**TOWN OF NEWBURGH
PLANNING BOARD
TECHNICAL REVIEW COMMENTS**

PROJECT: CORTLAND COMMONS
PROJECT NO.: 2017-11
PROJECT LOCATION: SECTION 9, BLOCK 1, LOT 60
REVIEW DATE: 4 OCTOBER 2017
MEETING DATE: 5 OCTOBER 2017
PROJECT REPRESENTATIVE: JMC PLANNING & ENGINEERING

RE: JMC Project 16055
 Route 9W Retail
 Route 9W
 Newburgh, NY

Response to MH & E "Town of Newburgh Planning Board Technical Review Comments", dated 03/16/2017

SP-16

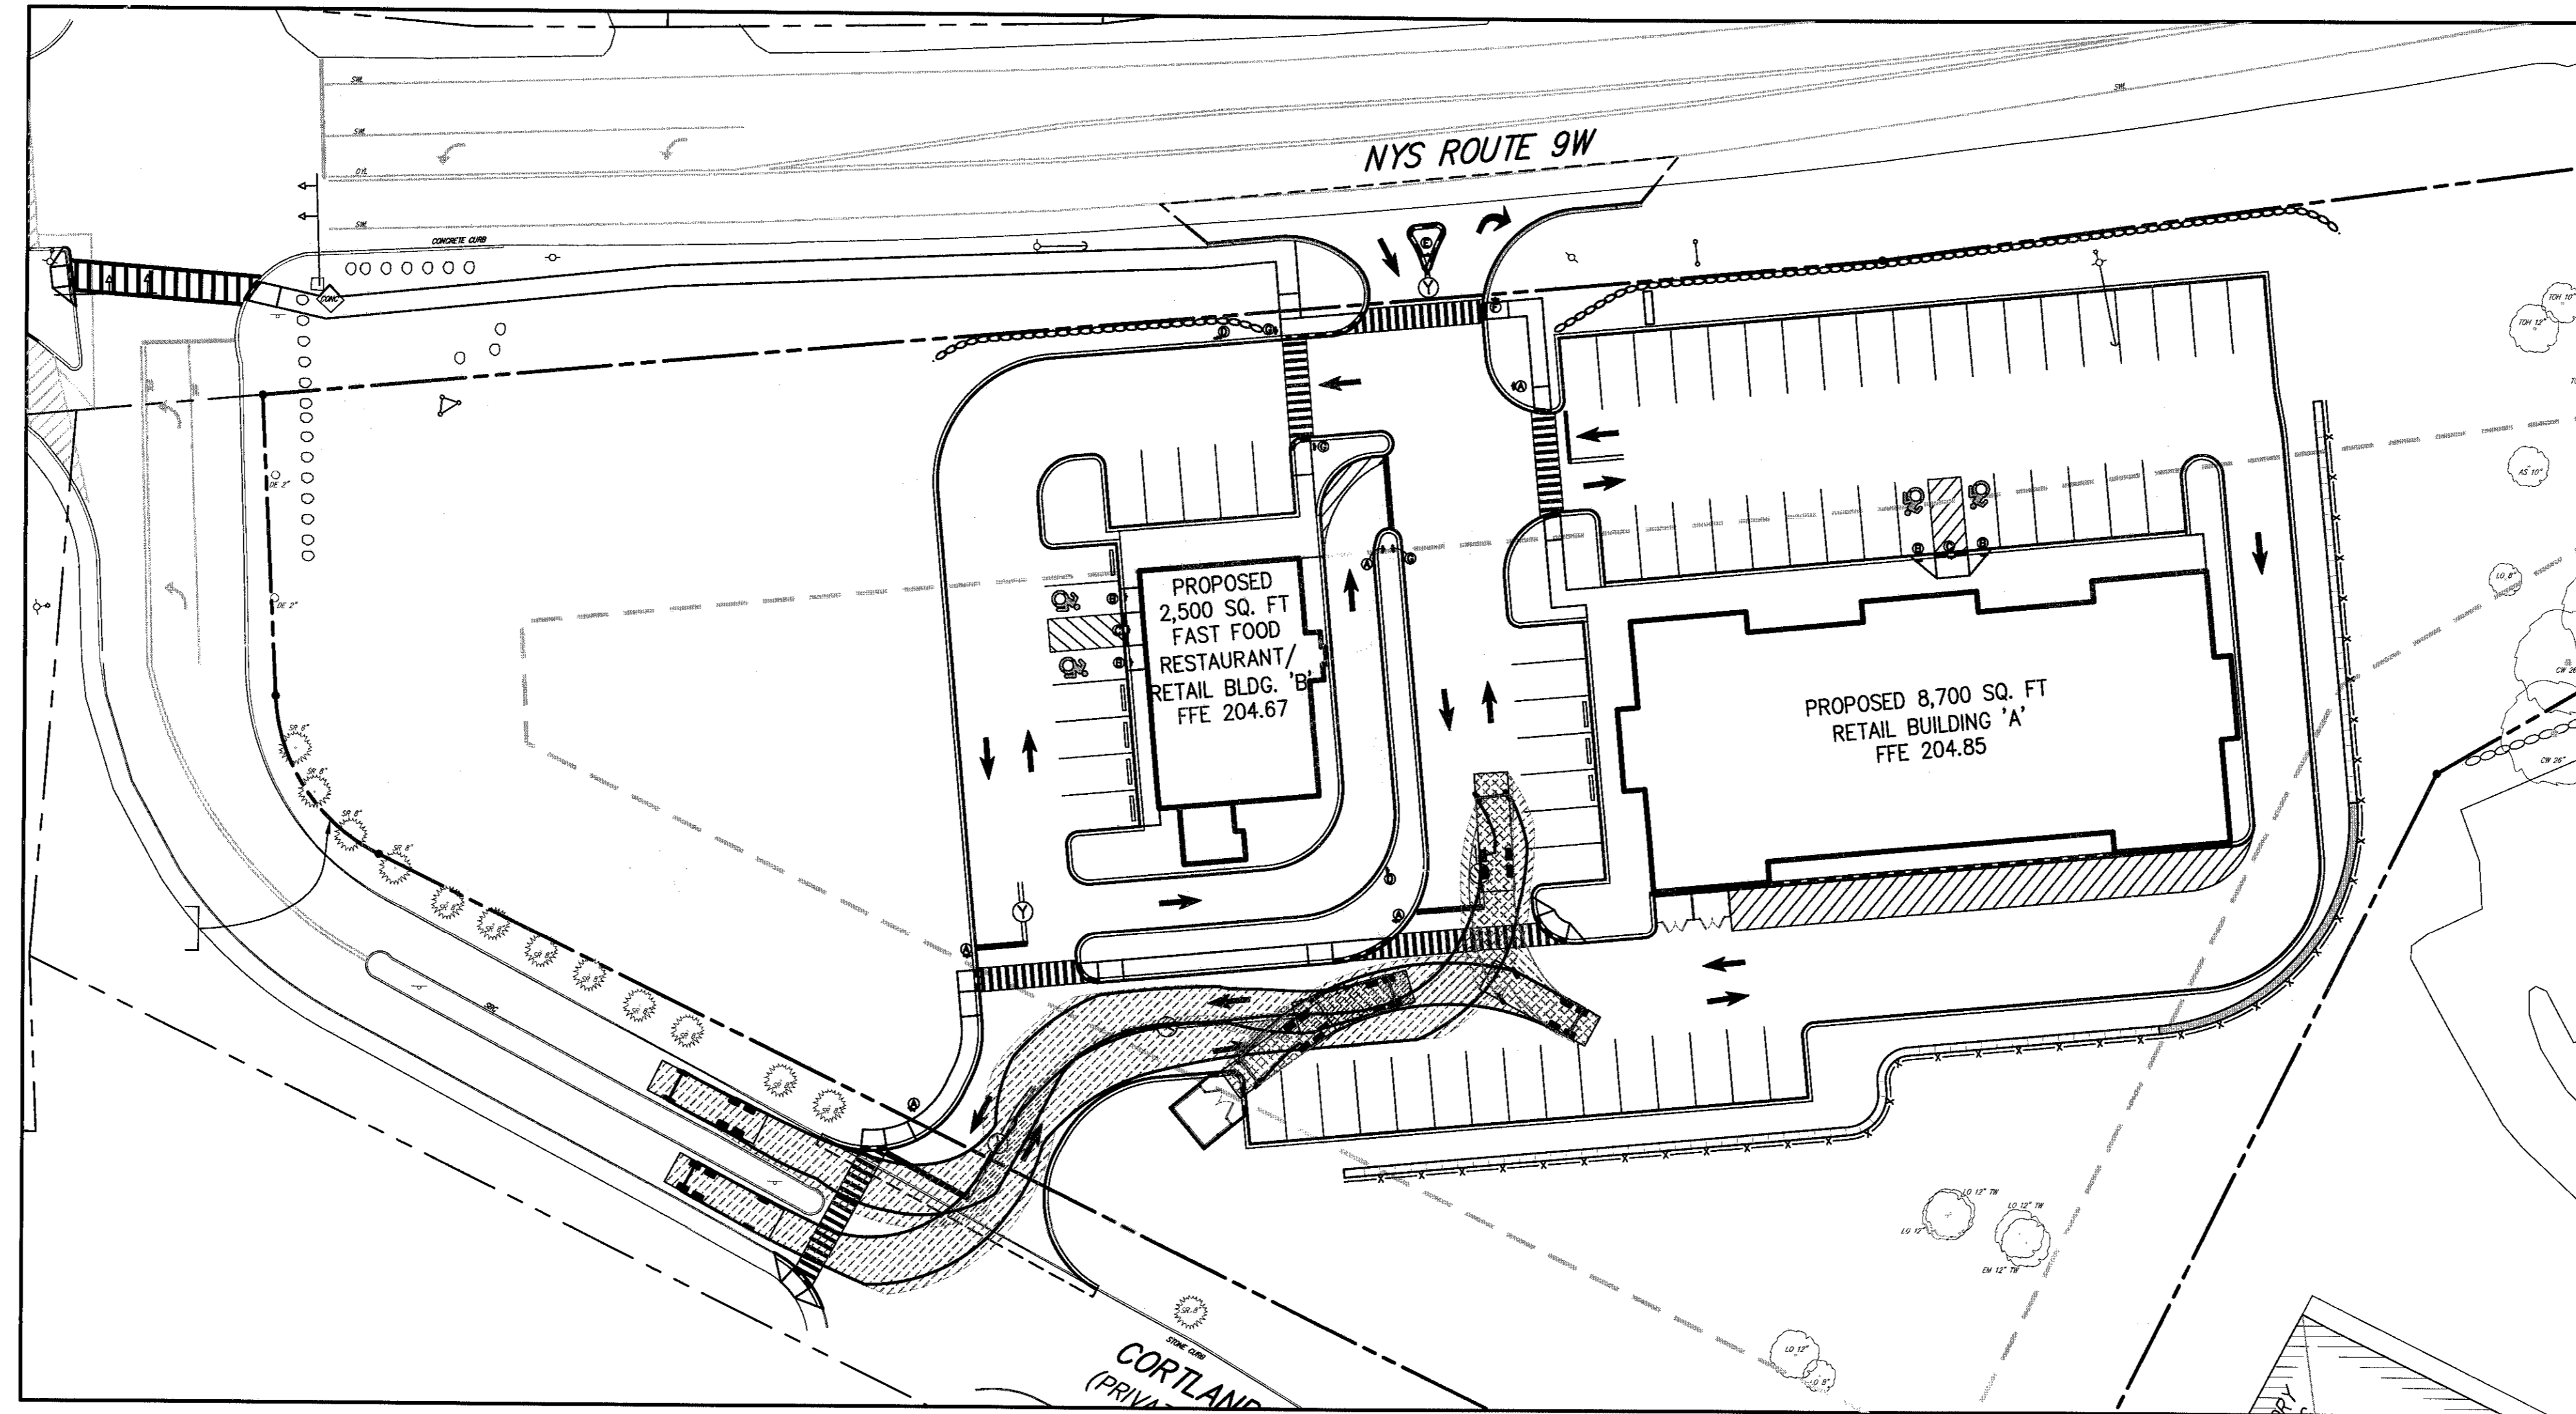
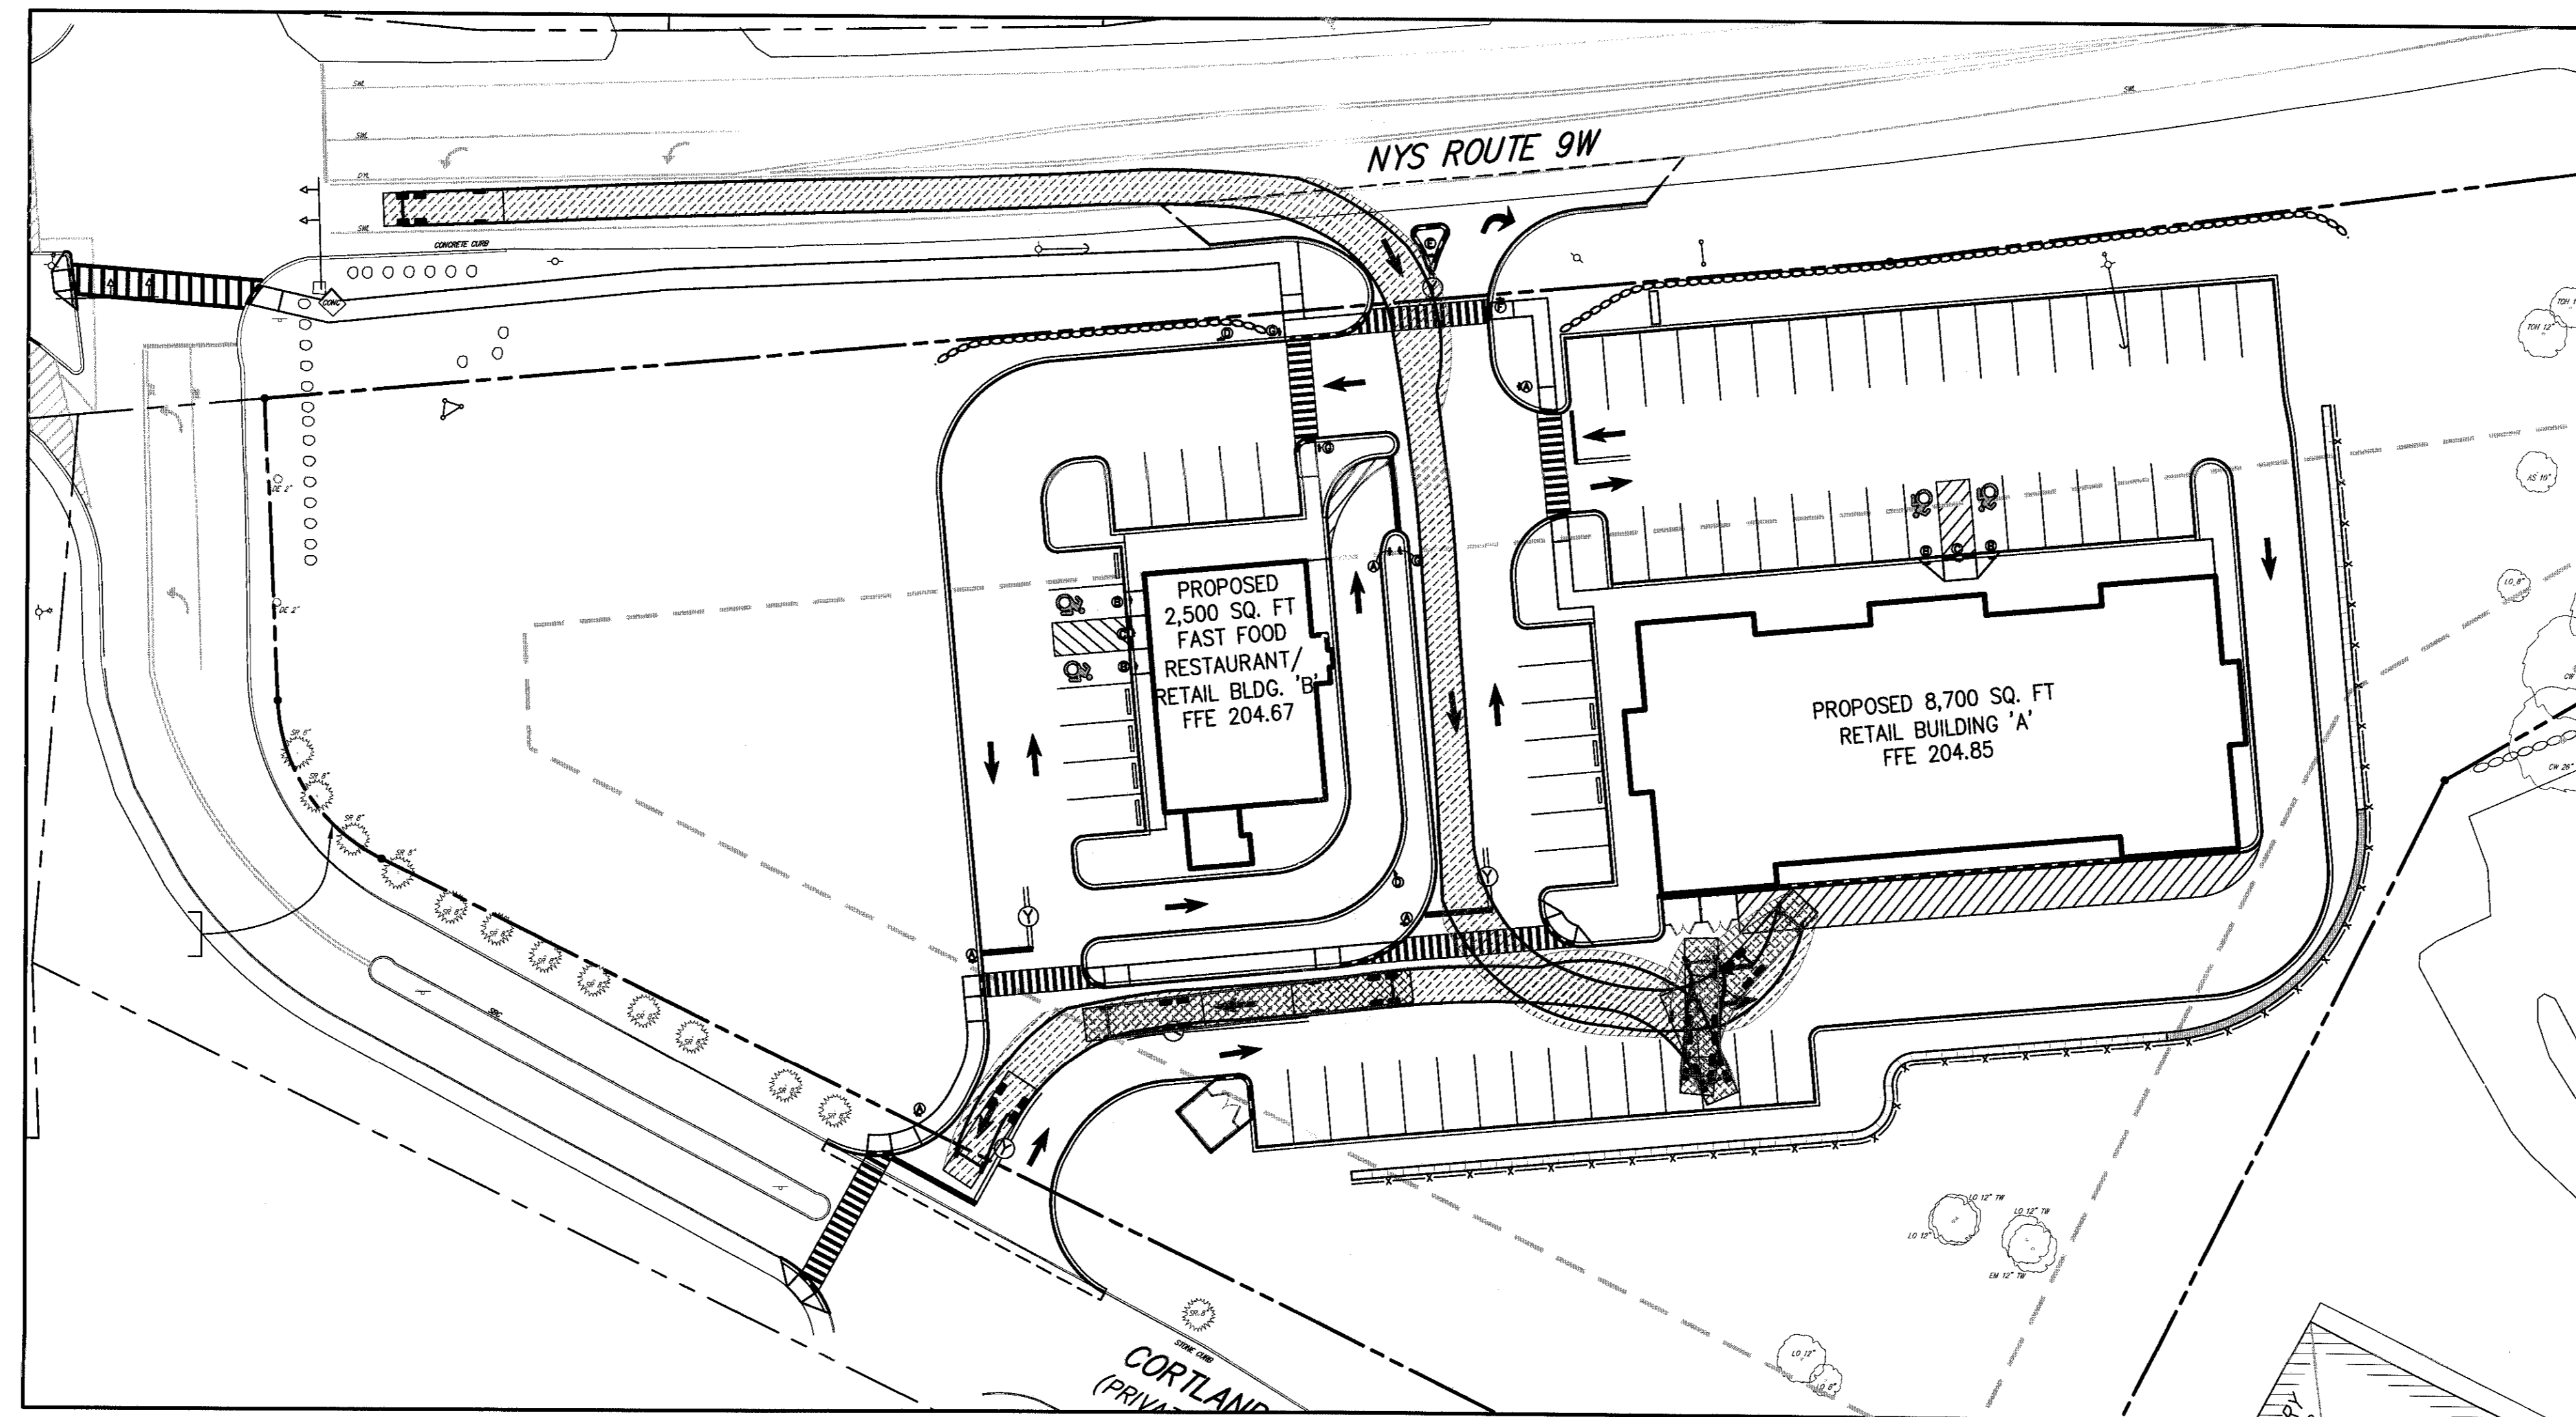
The garbage enclosure orientation may limit the ability for a front lift truck to access the dumpsters. A truck circulation plan should be prepared in future submissions.

SP-15 Truck Access Plan has been added to the drawing set to illustrate garbage truck turning maneuvers. The garbage enclosure locations have been modified to improve accessibility.
